The HPC approved a rear addition at 28 Hesketh, Chevy Chase in February 2010. The applicants proposed to relocate an existing 6' wood privacy fence forward approximately 15'. The HPC approved the new location but with a condition that the fencing be 4' tall.

Eckert-Sperl Addition  
28 Hesketh Street, Chevy Chase MD 20815

**MONTGOMERY COUNTY HISTORIC PRESERVATION COMMISSION**  
**STAFF REPORT**

<b>Address:</b>	28 Hesketh Street, Chevy Chase	<b>Meeting Date:</b>	2/10/10
<b>Resource:</b>	Contributing Resource Chevy Chase Village Historic District	<b>Report Date:</b>	2/3/10
<b>Applicant:</b>	Christopher Erckert and Christopher Sperl (Shawn Buehler, Architect)	<b>Public Notice:</b>	1/27/10
<b>Review:</b>	HAWP	<b>Tax Credit:</b>	None
<b>Case Number:</b>	35/13-10B	<b>Staff:</b>	Anne Fothergill
<b>PROPOSAL:</b> Rear addition, window replacement, patio installation, garage door and window replacement

1 ZONING SITE PLAN  
Scale: 1" = 10'-0"

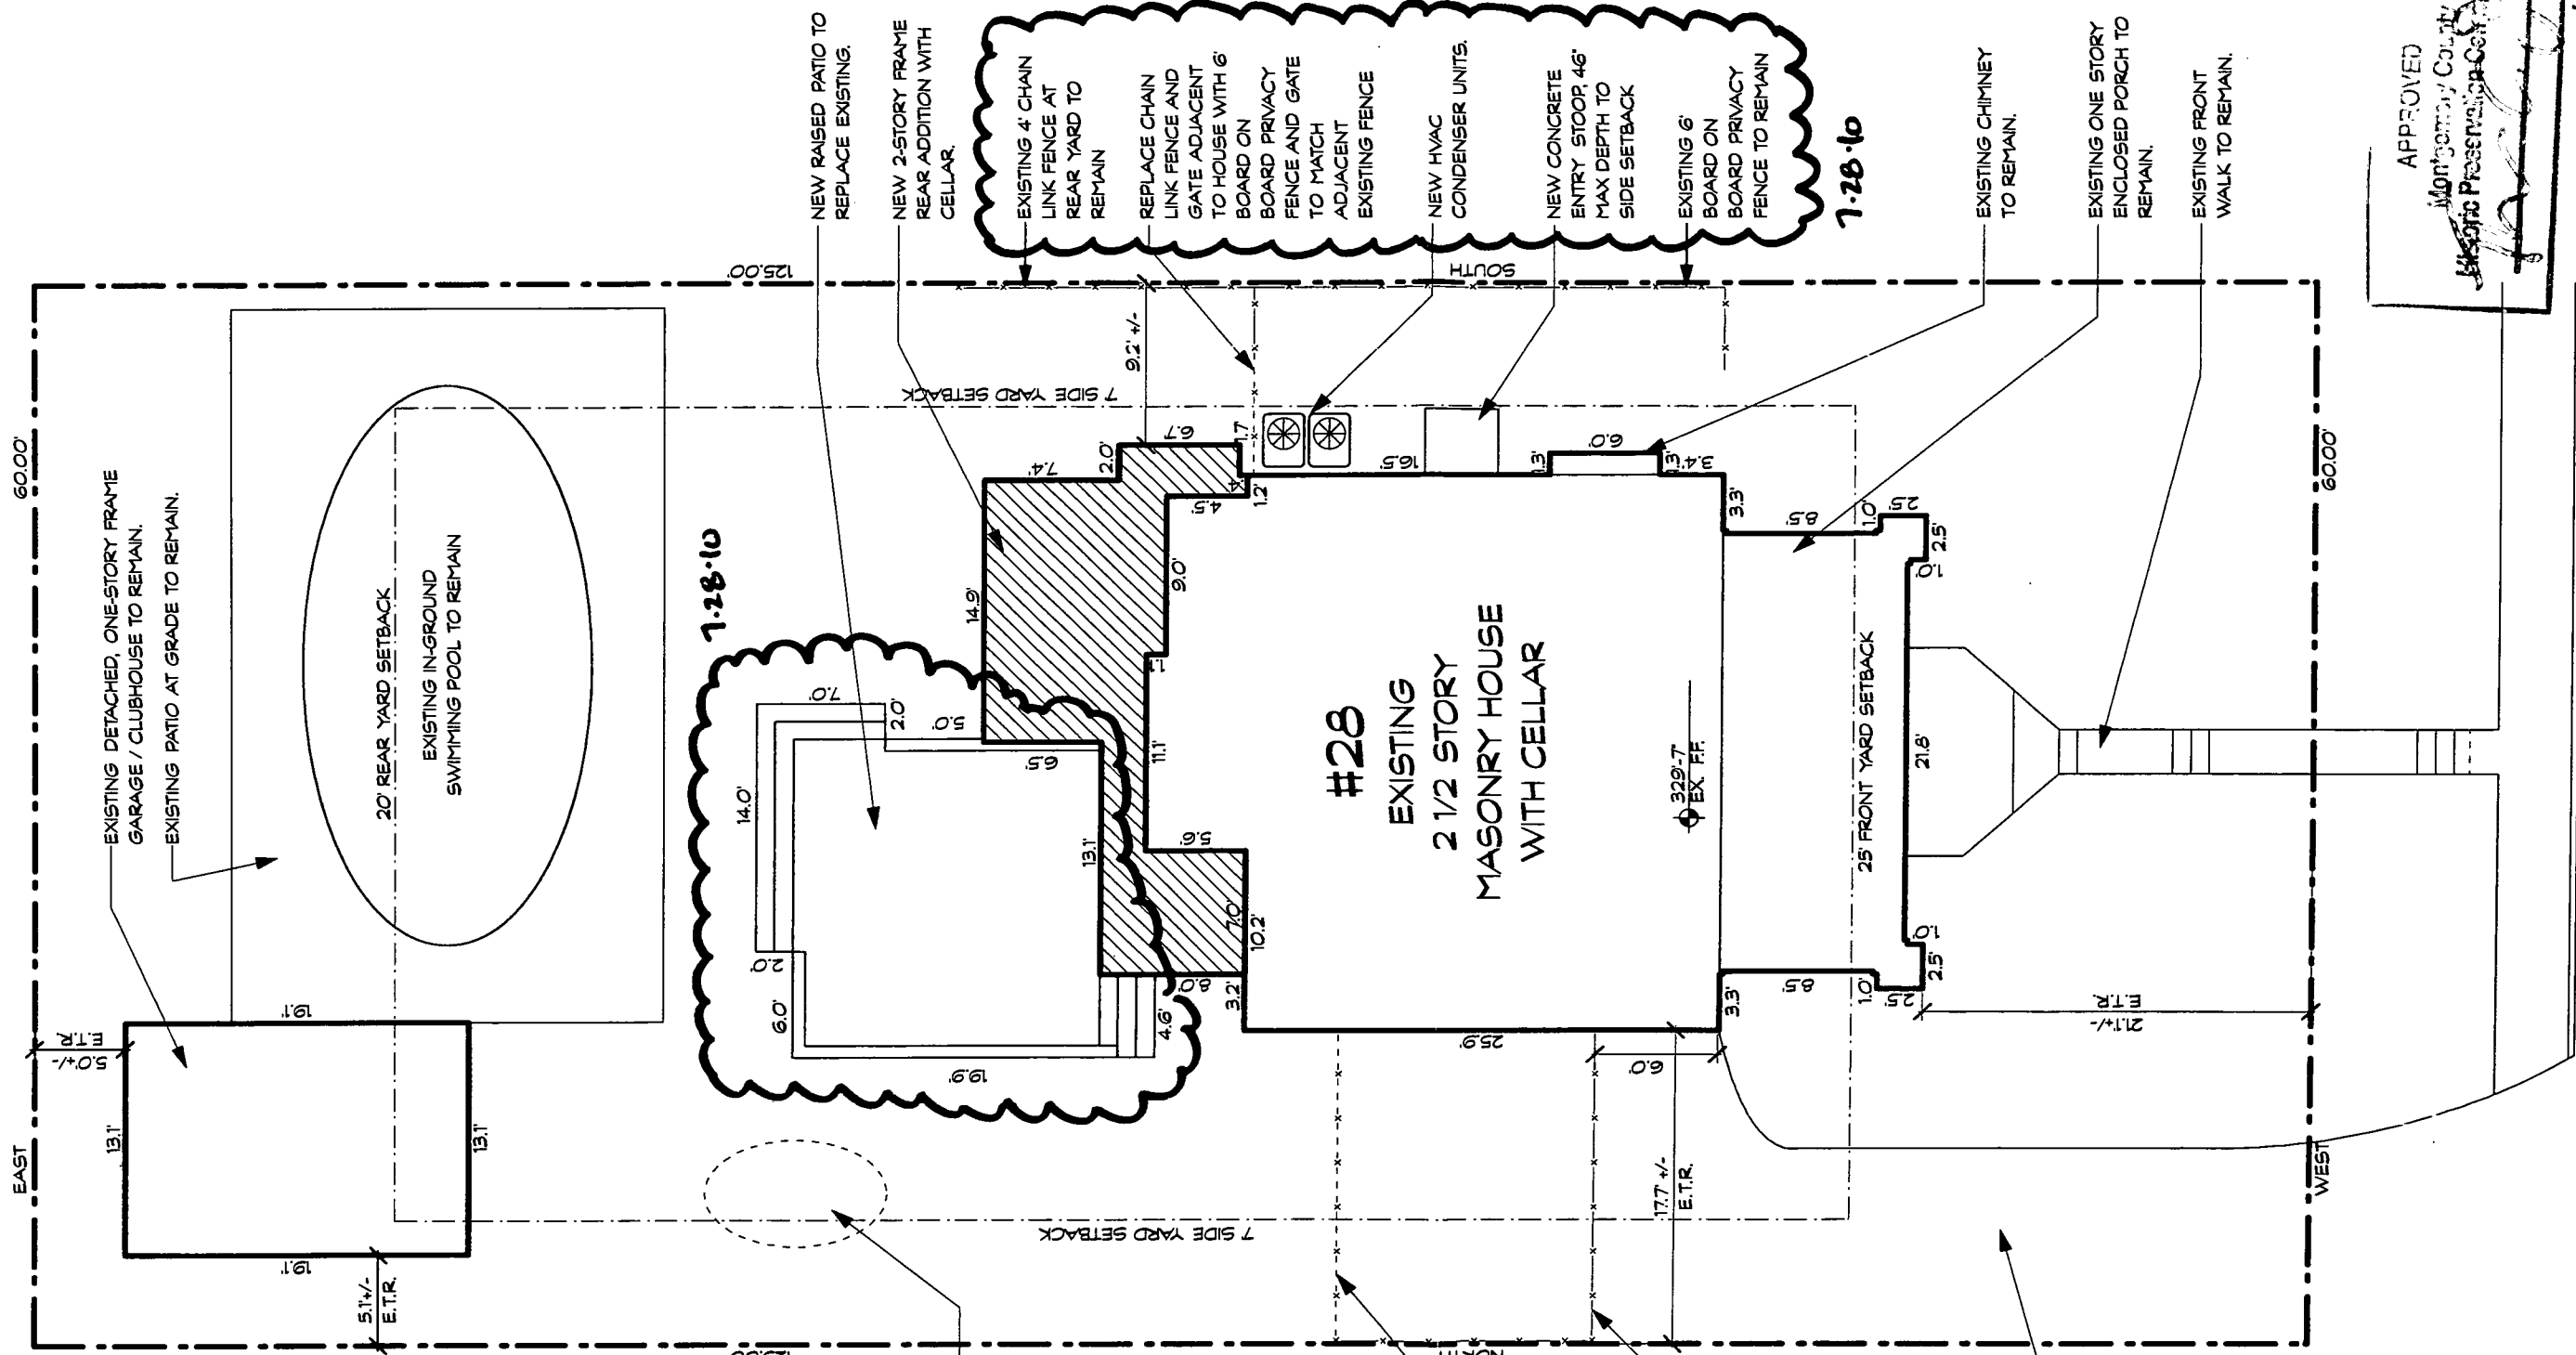
The applicants are now proposing:

- 1) The existing 6' privacy fence on the east side will be relocated to the west side of the house to replace the existing chain link fencing.
- 2) The new relocated wood fencing on the east side will be 5' tall, not 4', to meet Code for swimming pools.

While the HPC generally approves only 4' fencing until the rear plane of the house, exceptions for taller fences have been made on a case-by-case basis. Staff supports the 5' tall fencing in this location and requests that the HPC approve this change as a staff item.

OK

Proposed Site Plan  
Scale: 1" = 10'

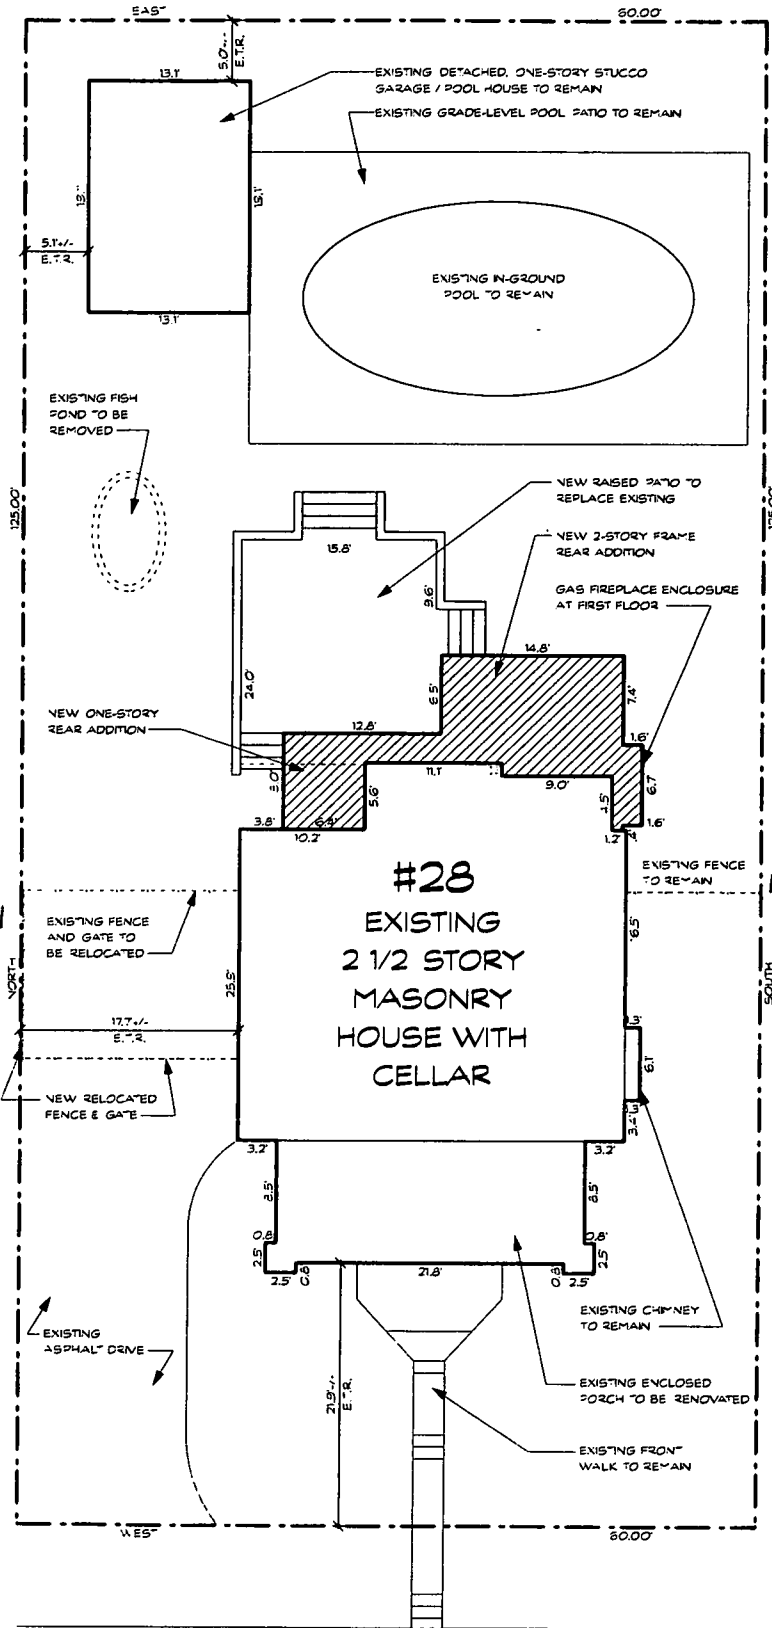
*6' wood fence to be moved*

*new 5' tall wood fence*

*wood fence relocated from east side to here (remove chain link fence)*

*proposed changes*
